Ford Motor Company

Re: Petition for Reconsideration – FMVSS 213, Child Restraint Systems  
(Docket 03-15351; 68 Fed. Reg. 37620, June 24, 2003)

Figure 2A

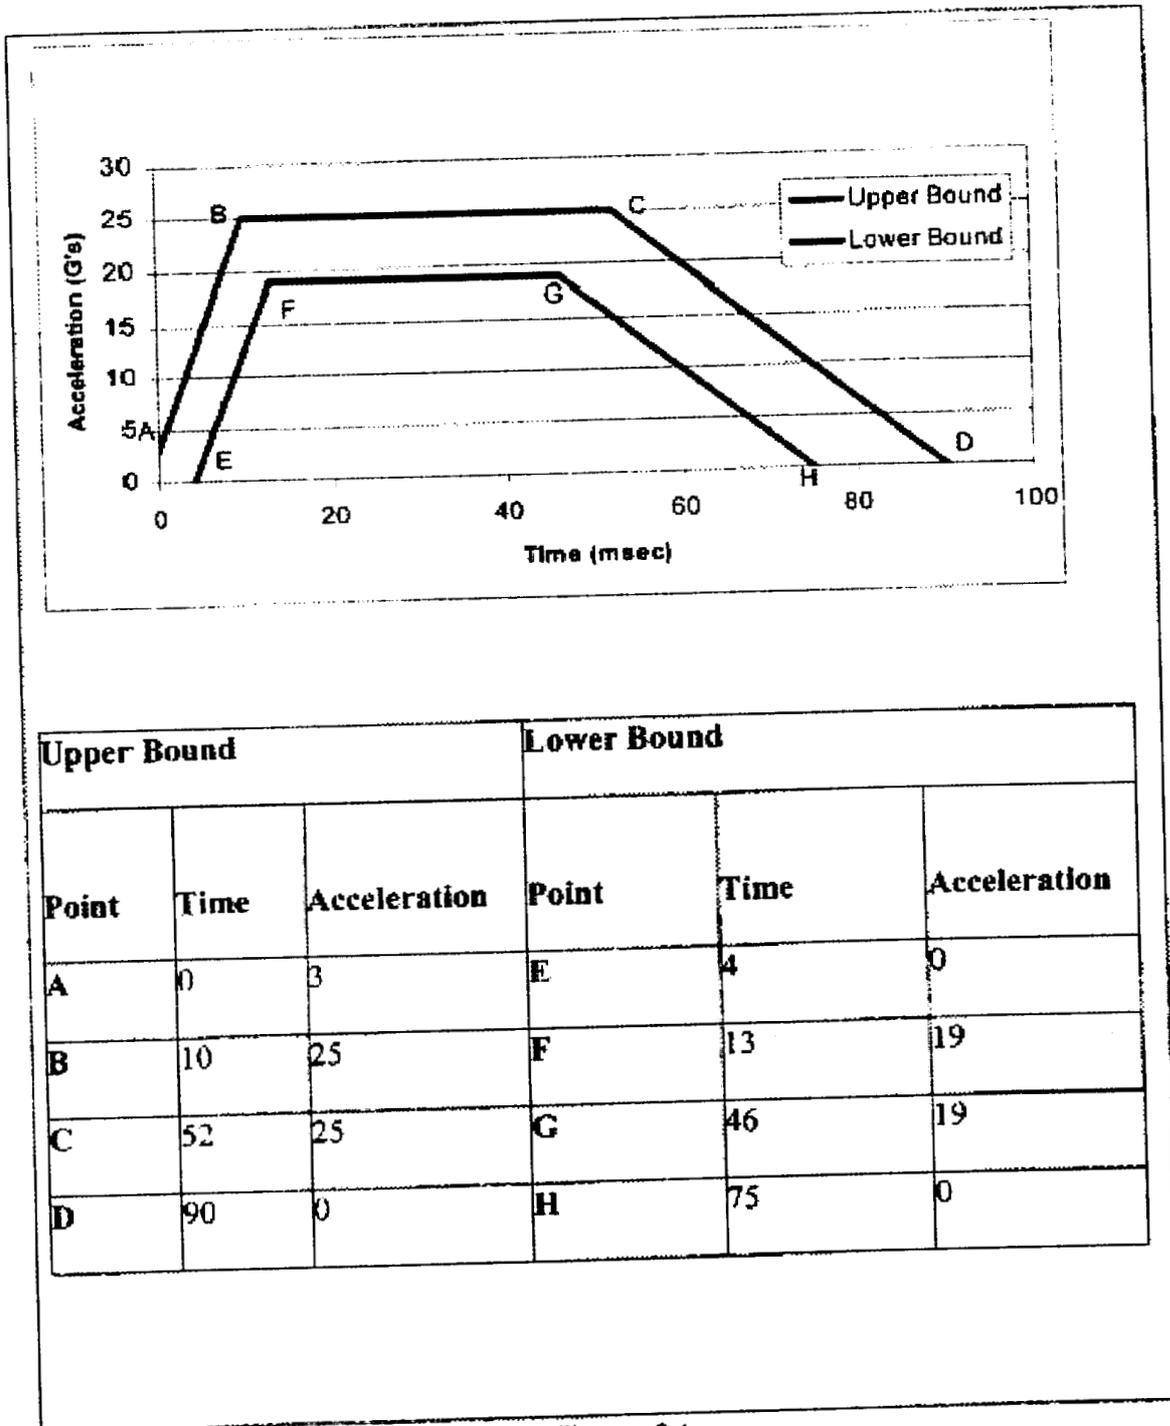
Allowing any 30 mph (48 km/h) pulse that can be contained within the corridors in Figure 2A would increase the resources required to offer built-in child seats, including built-in boosters. A vehicle manufacturer can choose to certify compliance of built-in child restraints using either the FMVSS 213 sled test pulse, or using a 30 mph (48 km/h) full-frontal barrier crash of the vehicle. Ford Motor Company prefers to test built-in child seats using the sled test alternative because barrier crash tests require significantly greater engineering resources. Sled test results are also more repeatable, and allow better camera coverage for development of design improvements. If a built-in child seat is to be offered on a new vehicle design, development and compliance crash tests must use hand-built prototype vehicles.

It would be substantially more difficult to consistently meet every FMVSS 213 test criterion using the most severe pulse permitted by the wider corridors of Figure 2A, however it is likely that more built-in child seat designs would have to be tested using the full-frontal barrier crash option. Increased use of the barrier crash alternative would unnecessarily increase development and certification test resource requirements, would delay introduction of built-in child seats, and therefore may further reduce potential availability of built-in child seats.

Figure A – High G 30 mph pulse

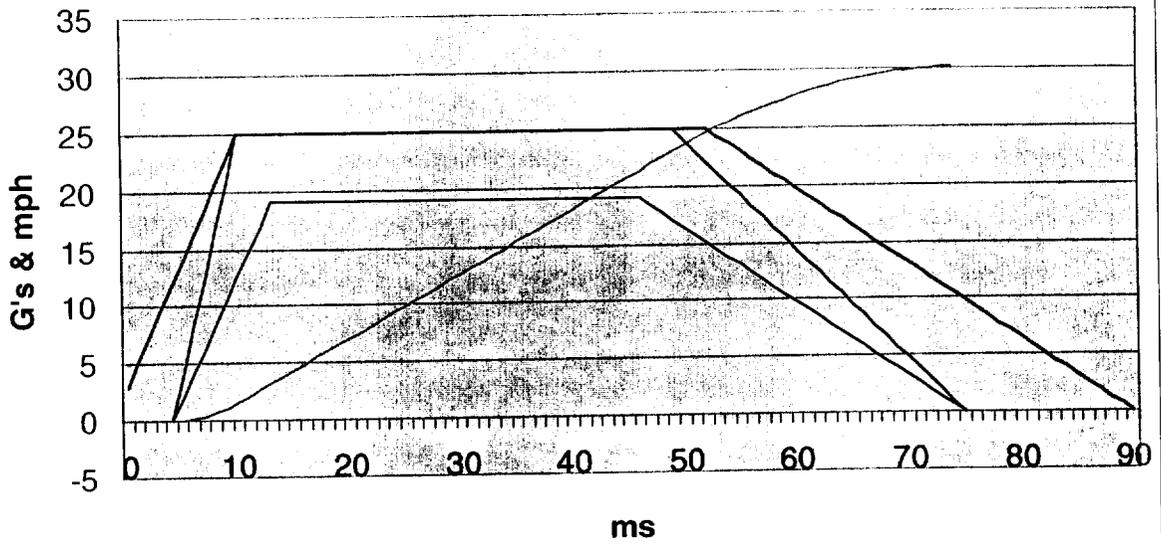
Figure A shows one of the most severe 30 mph theoretical pulses permitted by the new corridors. Note that the Figure A pulse does not maintain the peak acceleration of 25 g for the entire permitted interval, because doing so would exceed the 30 mph limit on  $\Delta V$ . Figure B shows what appears to be the least severe 30 mph  $\Delta V$  pulse permitted by the new corridors. Although both of these pulses have a 30 mph  $\Delta V$ , they are quite different in severity. The acceleration in the Figure B pulse averages 15.2 g, while the Figure A pulse averages 19.4 g, a 27% higher acceleration severity. Although these theoretical pulses cannot be achieved by any existing sled test technology, the latest servo-hydraulic sled control technology can come very close to replicating these pulse shapes. Ford believes that a pulse corridor that allows a potential 25% variation in pulse severity is not sufficiently objective. Further, we believe that the agency did not intend to permit a pulse with a significantly higher average acceleration than the current FMVSS 213 pulse.

To illustrate the effects of various potential pulses that meet the new pulse specifications, the following table shows 3-year-old Hybrid III dummy predicted results from a MADYMO model of a LATCH child restraint subjected to three 30 mph  $\Delta V$  pulses that fall within the new pulse corridors; the traditional FMVSS 213 pulse, the 25 g pulse of Figure A, and the 19 g pulse of Figure B. This MADYMO model is not fully representative of typical 213 compliance tests because it assumes a rigid generic child restraint structure, rigid generic LATCH and tether anchors, a short tether strap mounted high on the child restraint, and webbing characteristics similar to typical adult polyester belts. Because the resulting restraint model is stiffer than a typical add-on LATCH child restraint, the results from the model may be more indicative of generic built-in child restraint performance than of typical add-on child restraint test results. All of the simulations appear to meet the required performance criteria, but the differences are substantial, and the resultant chest acceleration during the most severe pulse is only 17% below the compliance limit.

Figure D – Modified Figure 2A Pulse (22 G)

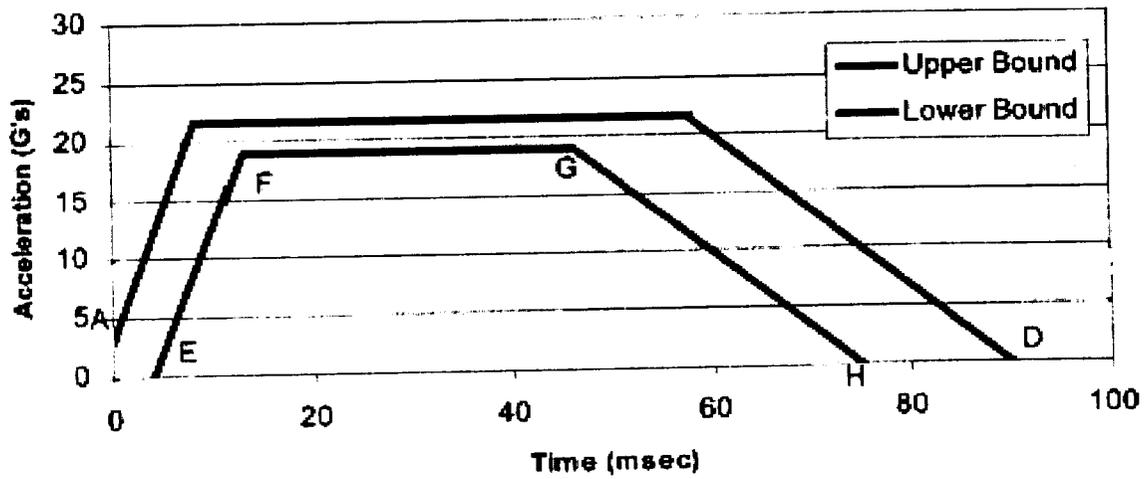
The agency could have increased the velocity change of the pulse without allowing a higher acceleration by maintaining the existing pulse corridors up to about 65 ms, and only widening the pulse bounds after 65 ms by drawing a new line between 15g @ 65 ms and 0g @ 90 ms to represent the new upper bound. The resulting pulse corridors are illustrated in Figure C attached, with the deleted portion of the existing pulse corridor dashed. If the agency wishes to provide an equivalent but simpler pulse that more test labs could consistently achieve, the pulse of Figure 2A could be modified by changing the peak acceleration to 22 g instead of 25 g (between 9 and 56 ms), as shown in Figure D attached. The pulse corridors in Figure D would allow a maximum theoretical velocity change of 33.4 mph over the full 90 ms pulse

interval. This would allow most sled tests to achieve a full 30 mph  $\Delta V$ , but would limit pulse severity to about the same average acceleration level specified by the old FMVSS 213 pulse.
